SUBJECT: Rio Mesa Solar (11-AFC-04) - Applicant's Comments on Preliminary Staff Assessment

**APPLICATION FOR CERTIFICATION FOR THE
RIO MESA SOLAR ELECTRIC
GENERATING FACILITY**

DOCKET NO. 11-AFC-04
PROOF OF SERVICE
(Revised 11/2/12)

**DRAWDOWN CONTOUR MAP COMPARISON
 YEAR 31 AT END OF RMS PUMPING**

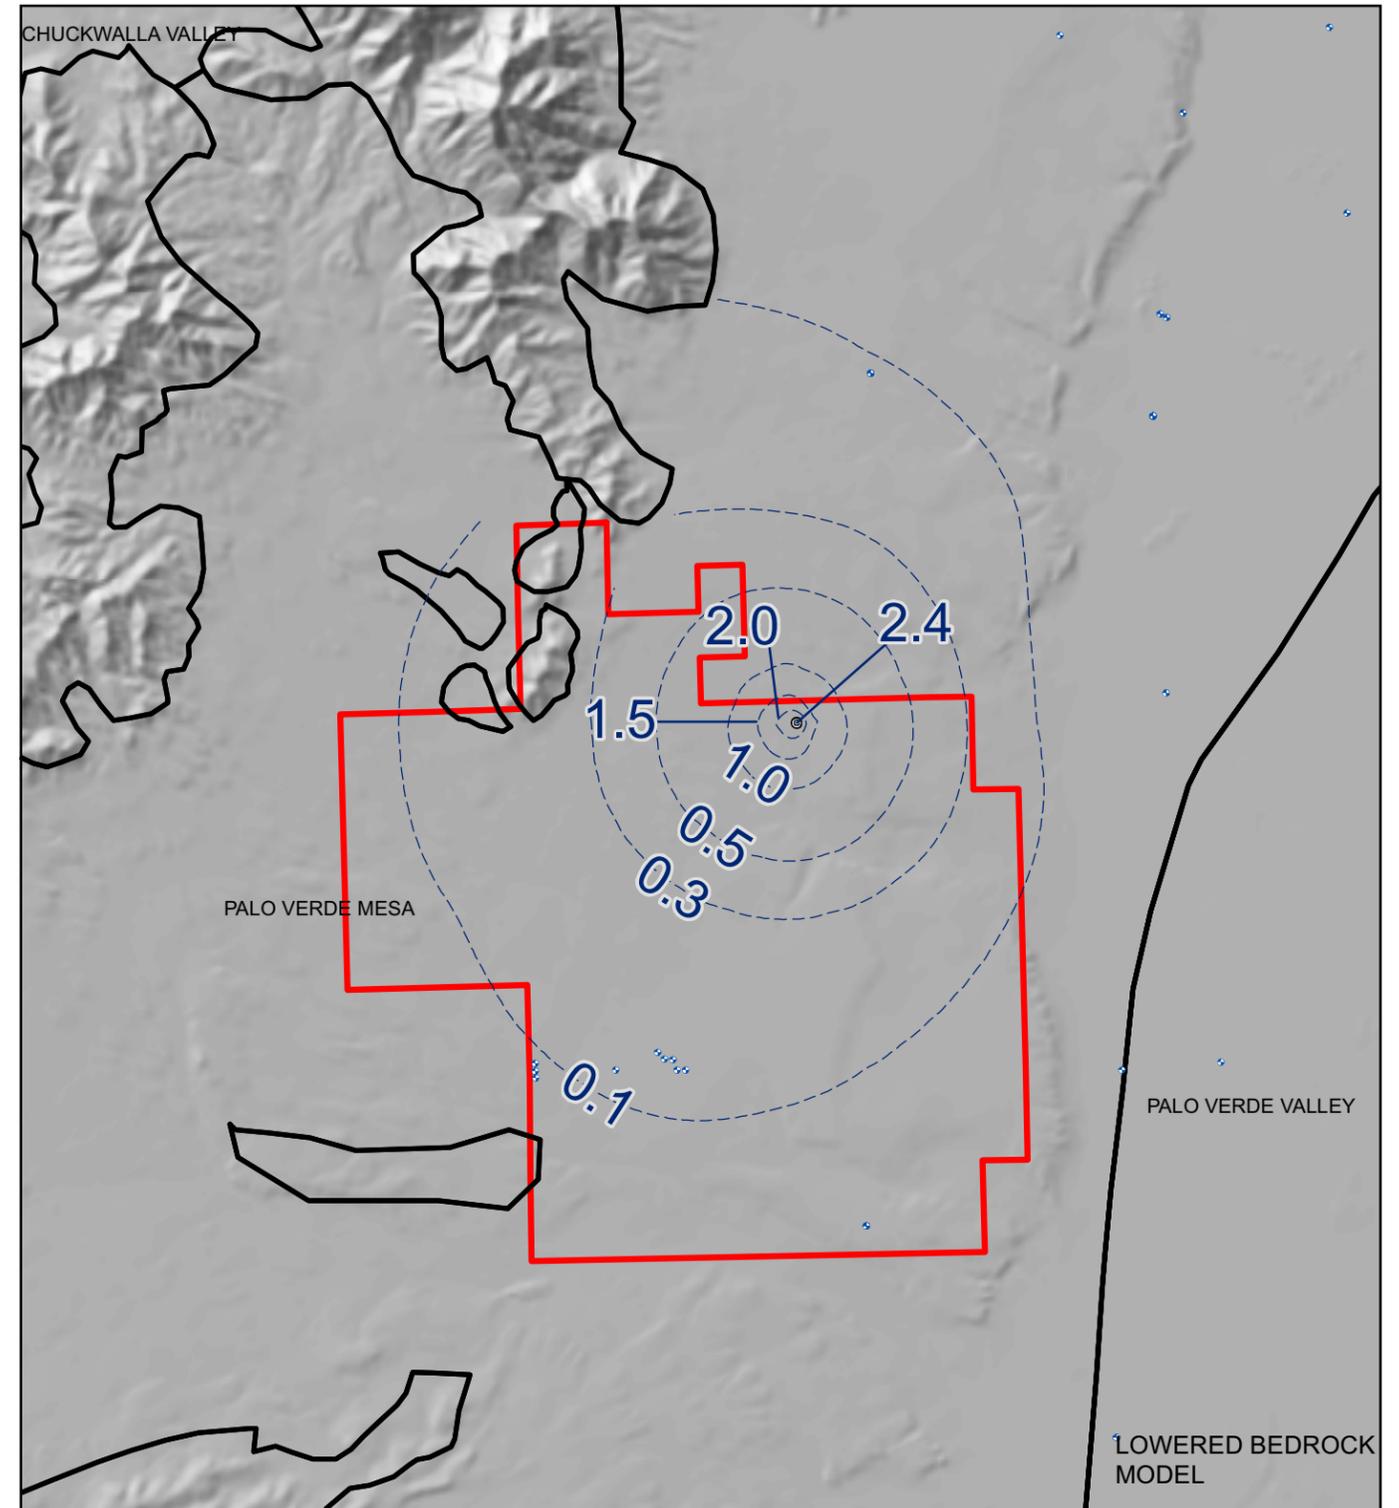
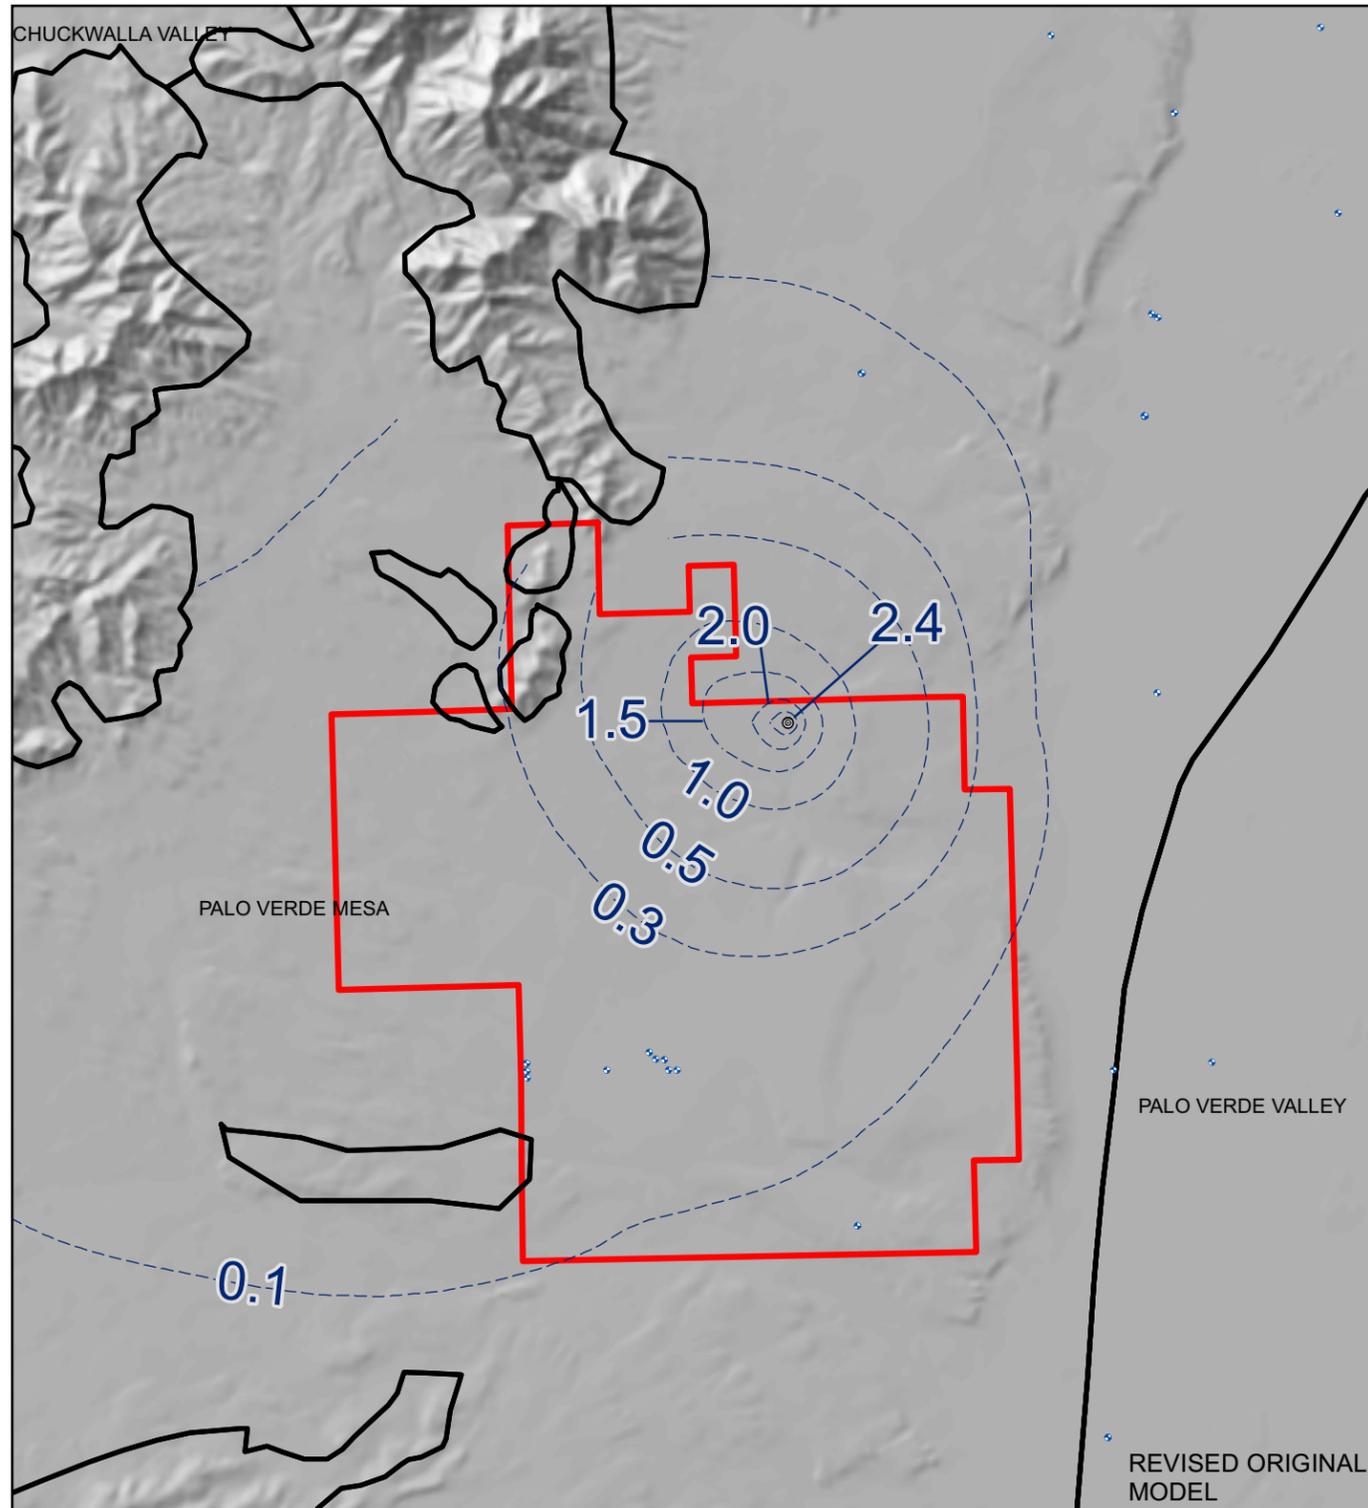
Figure 2 shows the project related drawdown predicted by the Lowered Bedrock and Revised Original models. Both model results show that project-related drawdown impacts will be less than significant. Consistent with previous studies provided to the CEC, drawdown decreases rapidly away from the pumping wells in the Lowered Bedrock and Revised Original models and is generally similar in extent. Both models predict that the 0.1 ft drawdown contour to the east of the RMS wells will occur in approximately the same locations and will not extend from Palo Verde Mesa Groundwater Basin into the Palo Verde Valley Groundwater Basin.

Hydrograph of Simulated Monitoring Well MW-4 for Revised Original Model

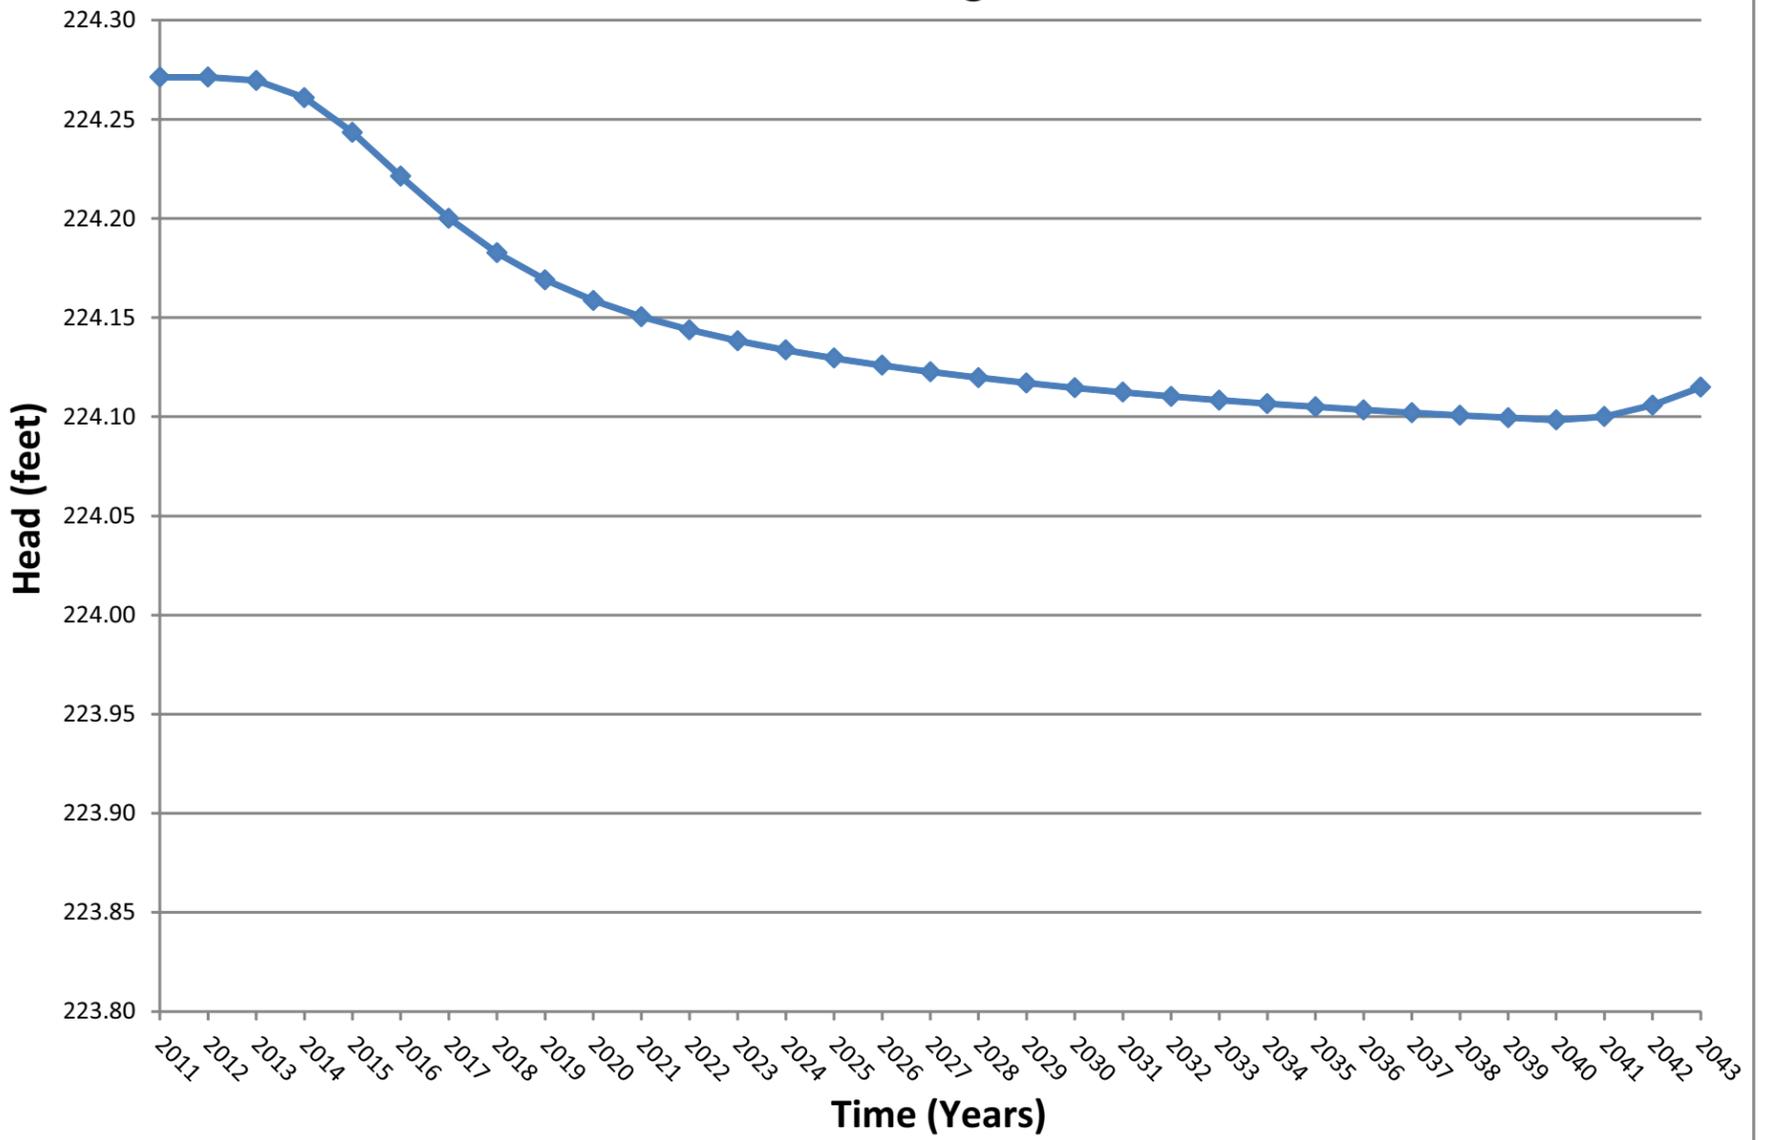
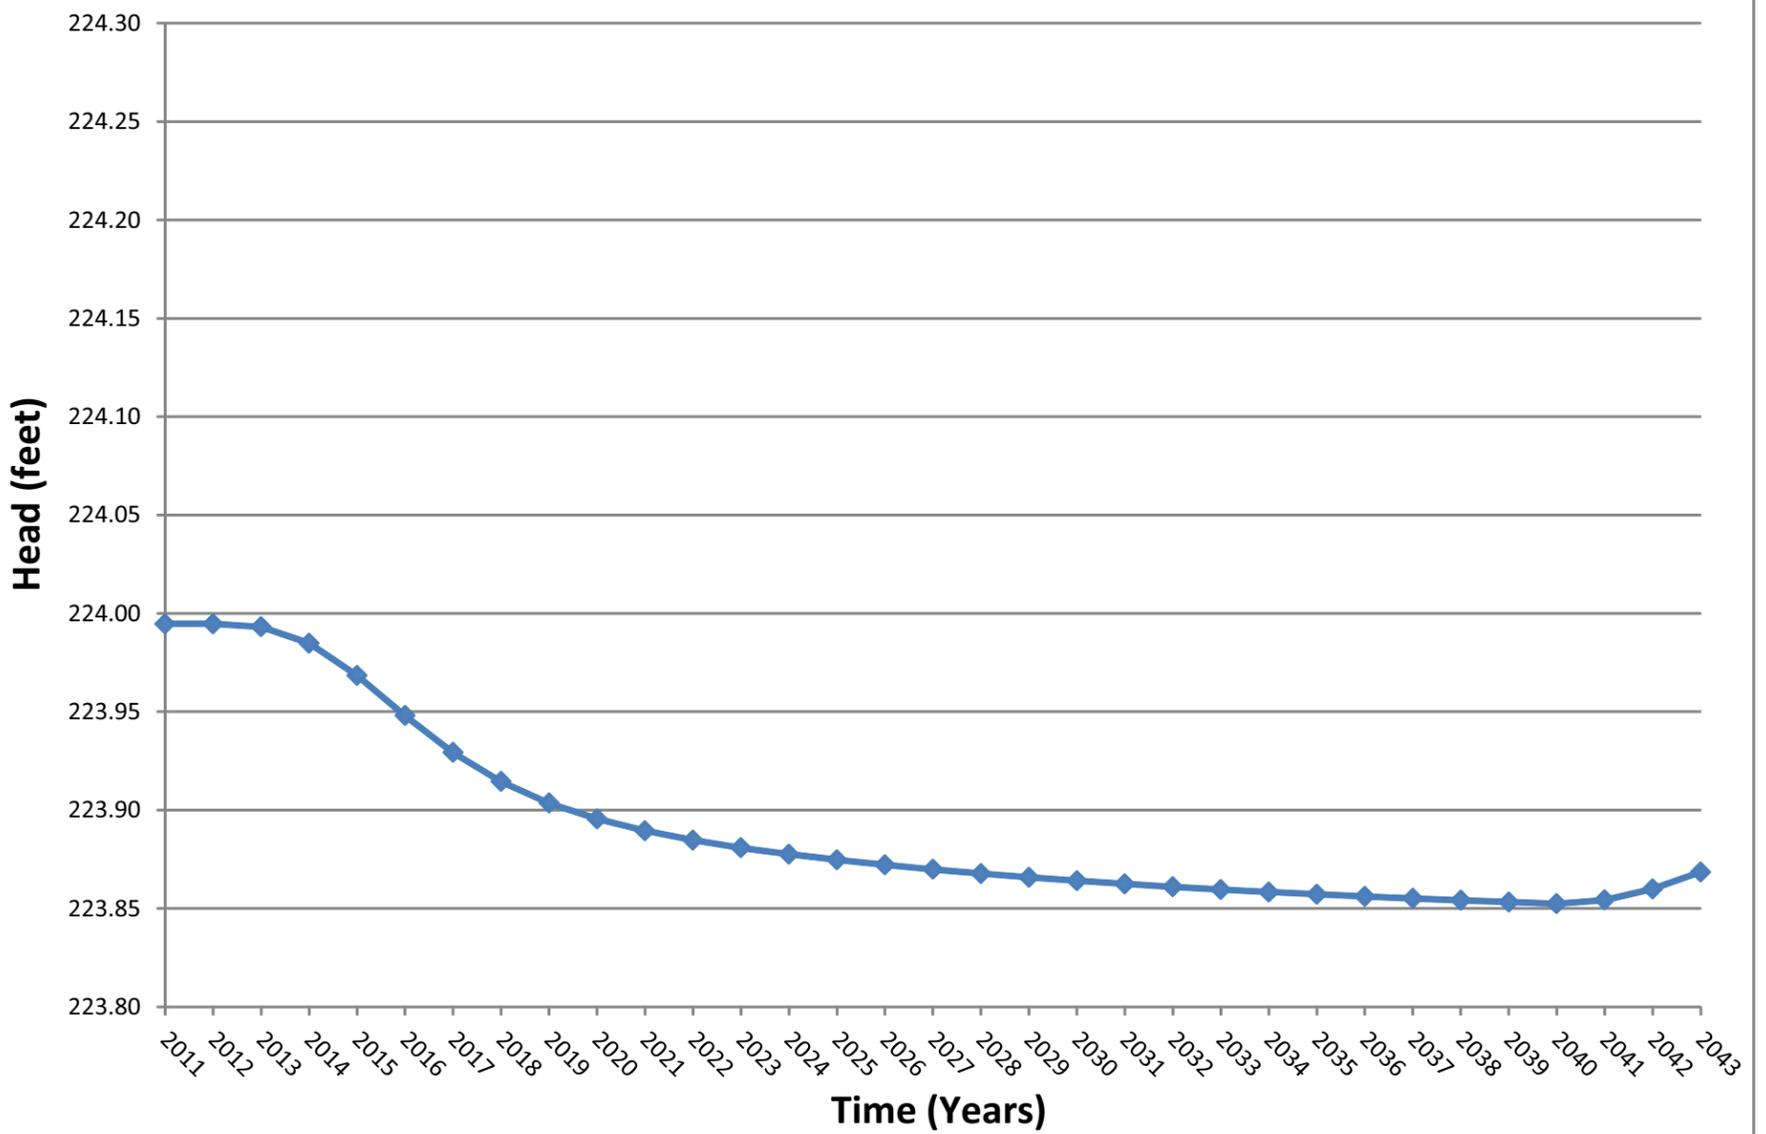
simulated monitoring well MW-4, located near the PVID drain at the foot of the mesa, is 0.17 feet in the Revised Original model, and 0.14 feet in the Lowered Bedrock model (Figure 4).
